Road Safety Audit Report

Incorporating
Stage 1 Completion of Preliminary Design; and
Design Team Response to items raised.

Proposed Highway Access off Roundstone Lane, Angmering

Job no	RSA-18-028	Issue no	3	Date	June 2018
Prepared by	JJF	Verified by	AJB	Approved by	JJF
Filename and Path	Fenley/Road Safety Audits/RSA-18/RSA-18-028-3

Item Location Plan

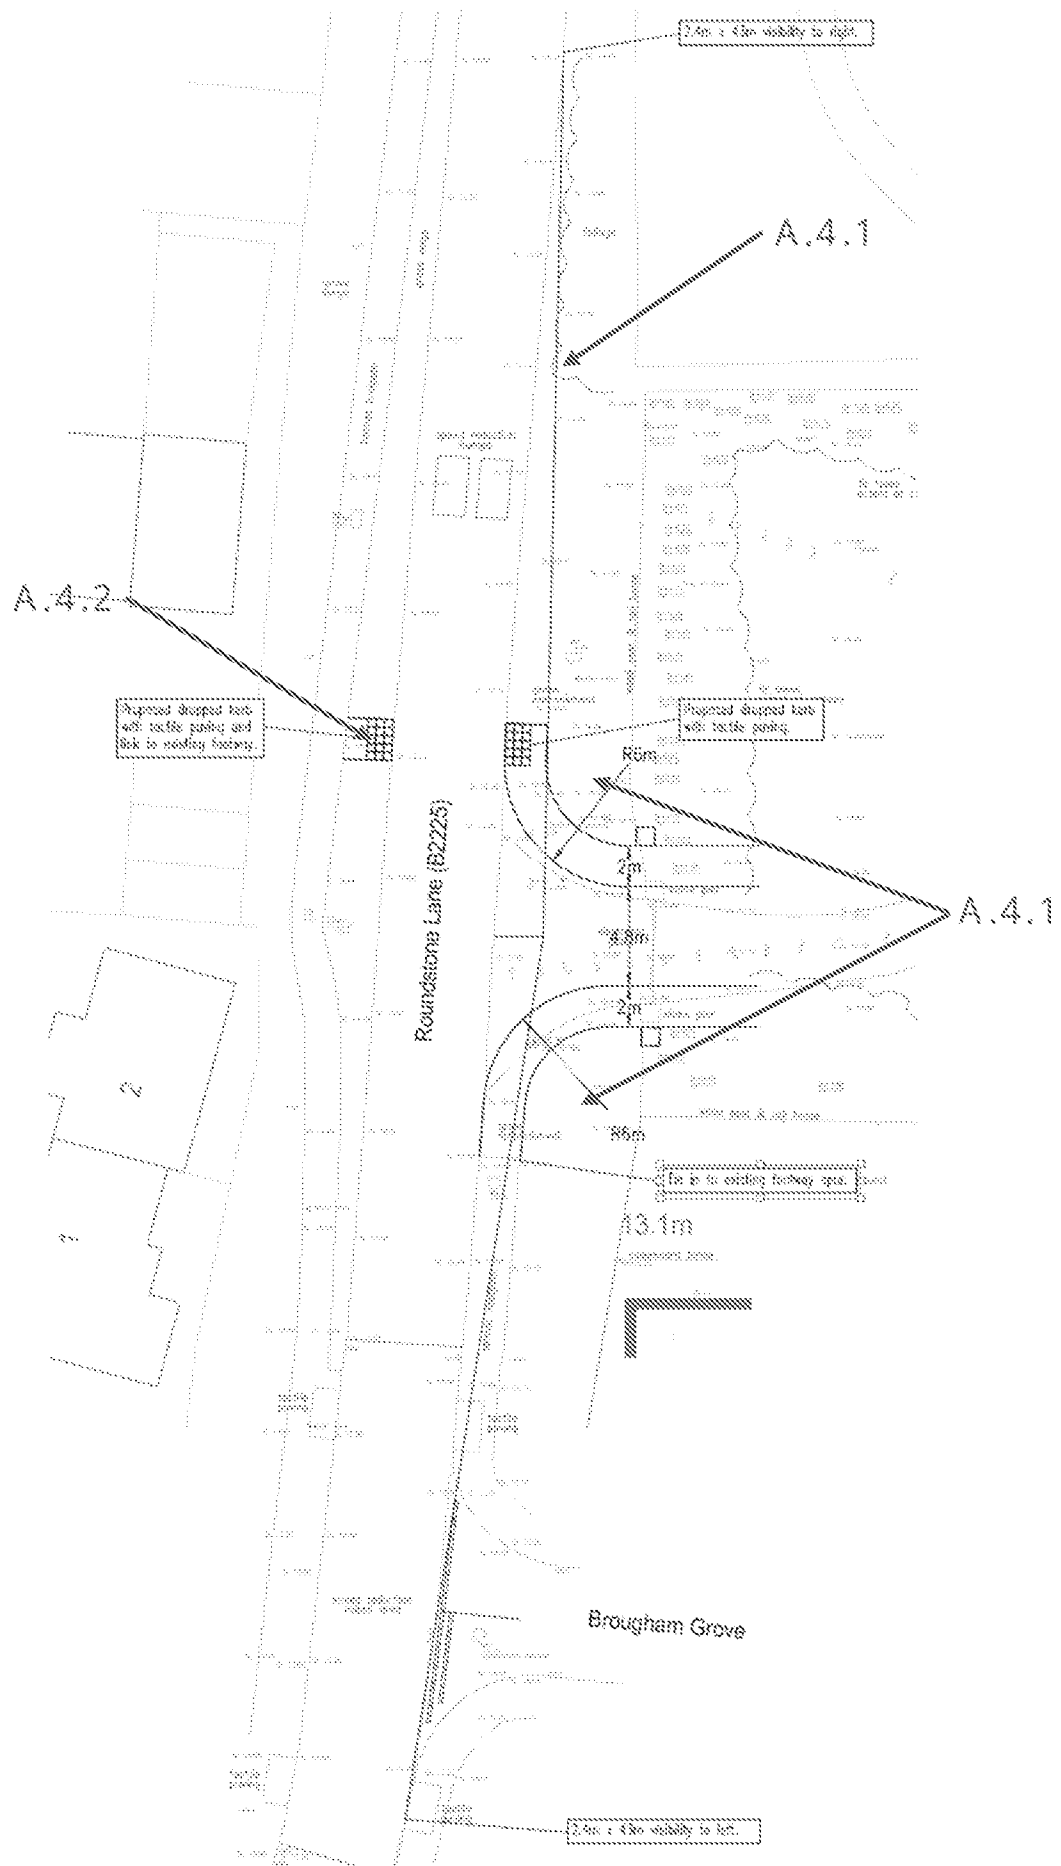
A.1	GENERAL
A.1.1	PROBLEM
Location:	Roundstone Lane eastern verge
Summary:	Existing vegetation restricts visibility to and from vehicles egressing
Acc. Type:	Heavy braking and side impact collisions
The scheme drawing provided with the Audit Brief illustrates that 2.4x43 metre visibility splays are achievable from the proposed access, however existing vegetation within the eastern verge of Roundstone Lane to the north is overgrown restricts visibility. Restricted visibility could result in a vehicle exiting the proposed access when it is not safe to do so and side impact collisions when southbound vehicles do not become aware of a vehicle egressing at a safe distance to slow / stop.	
RECOMMENDATION:	
It is recommended that a sufficient level of visibility is achievable at all times.	
Location Plan: 	
DESIGN TEAM RESPONSE provided by Development Transport Planning on the 6th June 2018 following formal issue of this Stage 1 Road Safety Audit on the 5th June 2018

A.4	NON-MOTORISED USER (NMU) PROVISION
A.4.1	PROBLEM
Location:	Eastern verge of Roundstone Lane
Summary:	Existing topography of the land adjacent to the proposed footway could result in a significant crossfall along the proposed footway
Acc. Type:	Pedestrian trip / fall, vehicle wheeled user collision
The existing verge to the east of Roundstone Lane is formed as an embankment graded up to the carriageway. As such, and as no retaining structures are detailed on the scheme drawing, the proposed footway is likely to accommodate a steep crossfall. A footway crossfall in excess of 3% are uncomfortable for pedestrians to walk along and could result wheeled users inadvertently falling towards the carriageway.	
RECOMMENDATION:	
It is recommended that a retaining structure is provided to ensure the crossfall does not exceed 3%	
Location Plan: 	
DESIGN TEAM RESPONSE provided by Development Transport Planning on the 6th June 2018 following formal issue of this Stage 1 Road Safety Audit on the 5th June 2018

The crossfall of the proposed footway will be considered as part of the detailed design of the highway works and it is envisaged that a solution similar to that adopted to the south of the access and shown in the photographs would be used for the new sections of footway.	
A.4.2	PROBLEM
Location:	Western verge of Roundstone lane
Summary:	Levels of existing footway and carriageway could result in a ramp down / up to the proposed crossing point
Acc. Type:	
The existing footway along the western side of Roundstone Lane is approximately 400mm above the carriageway level with a 2 metre verge where a crossing point is proposed. As such, the link between the footway and crossing will slope at a gradient of 1 in 5. A ramp towards the carriageway is uncomfortable for wheelchair users and could result in a user inadvertently

entering the carriageway when it is not safe to do so.	
RECOMMENDATION:	
It is recommended that the ramp down to the carriageway is reduced to a maximum gradient of 1 in 12.	
Location Plan: 	
DESIGN TEAM RESPONSE provided by Development Transport Planning on the 6 th June 2018 following formal issue of this Stage 1 Road Safety Audit on the 5 th June 2018	
The gradient of the proposed footway connection across the verge to the existing footway on the west side of Roundstone Lane will be considered as part of the detailed design of the highway works and will need to be approved by the highway authority. This will ensure that an appropriate gradient will be provided.	
A.5	ROAD SIGNS, CARRIAGEWAY MARKINGS AND LIGHTING
A.5.1	No road safety concerns regarding ROAD SIGNS, CARRIAGEWAY MARKINGS AND LIGHTING have been raised at this stage

Regular maintenance of the vegetation in the verge will ensure that sightlines are achieved and the care home management will be able to ensure this is done as part of the maintenance of the site landscaping.	
A.2	LOCAL ALIGNMENT
A.2.1	No road safety concerns regarding LOCAL ALIGNMENT have been raised at this stage
A.3	JUNCTIONS
A.3.1	No road safety concerns regarding JUNCTIONS have been raised at this stage
